NEWKIRK ENGINEERING, INC.

**RE: VYSTAR CREDIT UNION
16181 NW US HIGHWAY 441
COMPLETENESS REVIEW # 2**

The following comments are in response to your letter dated May 30, 2017:

Left Elevation

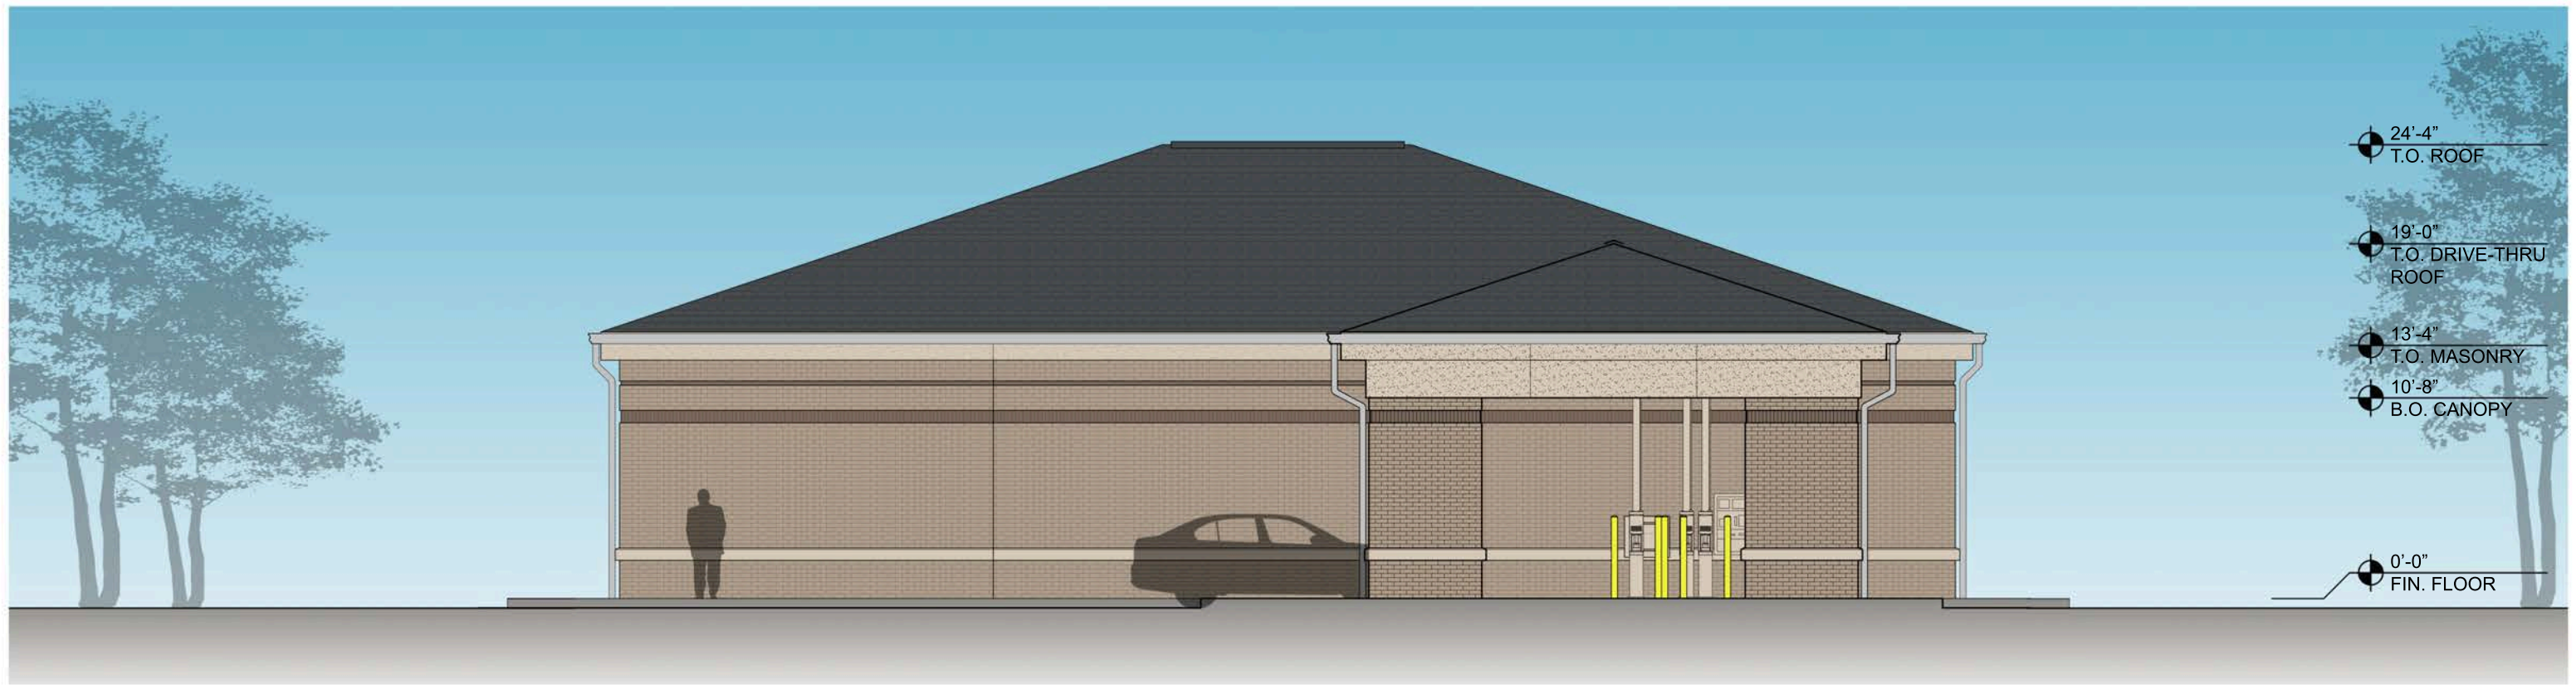
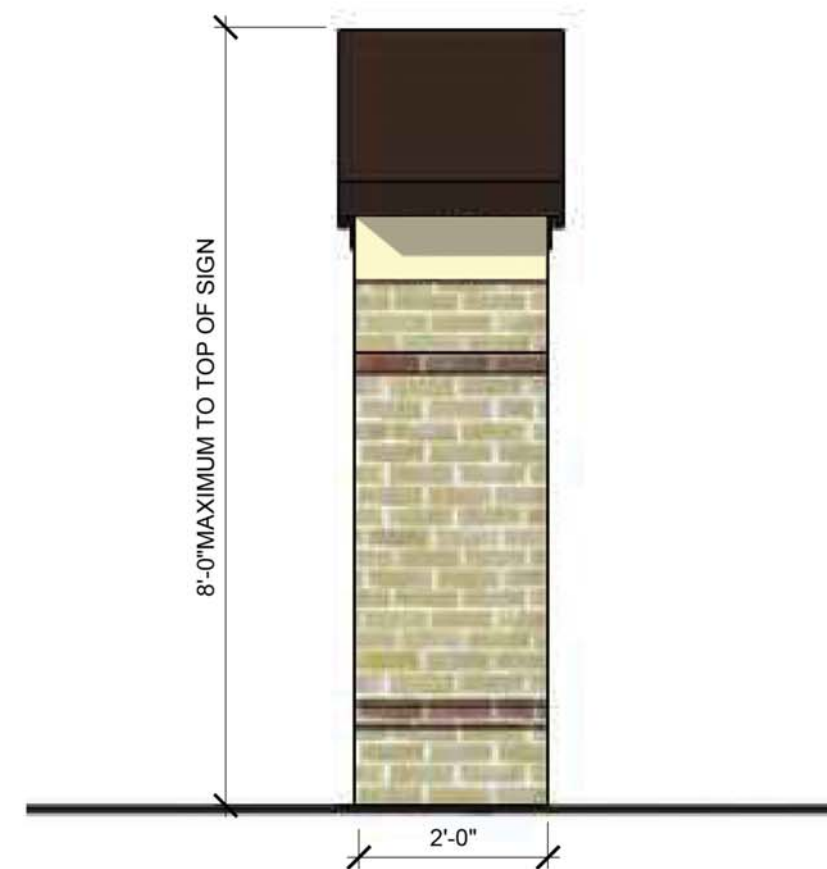
1. Section 6.1 – Off-street parking and loading standards
 - a. Please clarify on Sheet 3 that an administrative adjustment was requested per Section 6.1.4(B)(5)(b).
Note: Clarification should replace the Site Development Usage Note 5 B (Parking Provided”). **Response: Note 5A states than an Administrative adjustment was requested per Section 6.1.4(B)(5)(b). Note 5B was removed from the plans.**
6. Section 6.8- Design Standards for Business Uses
 - a. Section 6.8.2 (A)(2)(a)(i)a requires a minimum of 20% glazing when a façade faces a street or when it faces a publicly accessible parking area that consists of 15% or more of the minimum

off-street parking requirement. The minimum off-street parking requirement is 20 spaces for this project so the glazing minimum of 20% would apply to those facades that are street facing or have 3 or more parking spaces facing that façade. Both the right and left elevations as noted in the architectural plans have 4 parking spaces each on their respective façade sides. Therefore, the minimum glazing requirement is 20% for both the right and left façade.

Note: Facades do not appear to have been modified, but façade calculations have been changed. Please clarify calculations of façade area.

Response: The current architecture plans and color renderings meet the glazing requirements. The calculations for the percentage of glazing for the previous first submission was calculated incorrectly. The calculations for the gross area of the side elevations included the open area of the drive-thru and entry which should not have been taken into account for the surface area of the left or right side elevations. The floor plan and elevations were designed to provide the maximum amount of daylight into the interior space where possible without compromising security within the Branch. As shown on the floor plan, the wall spaces include the maximum coverage of glazing within the open areas and offices. The chart below provides the additional information of the square footage calculations.

LEFT & RIGHT FINISH PERCENTAGES		
DESCRIPTION	%	SF
TOTAL SQ FT LEFT FINISH = 790 SF		
GLAZING	24%	190
BRICK	65%	513
STUCCO	11%	87
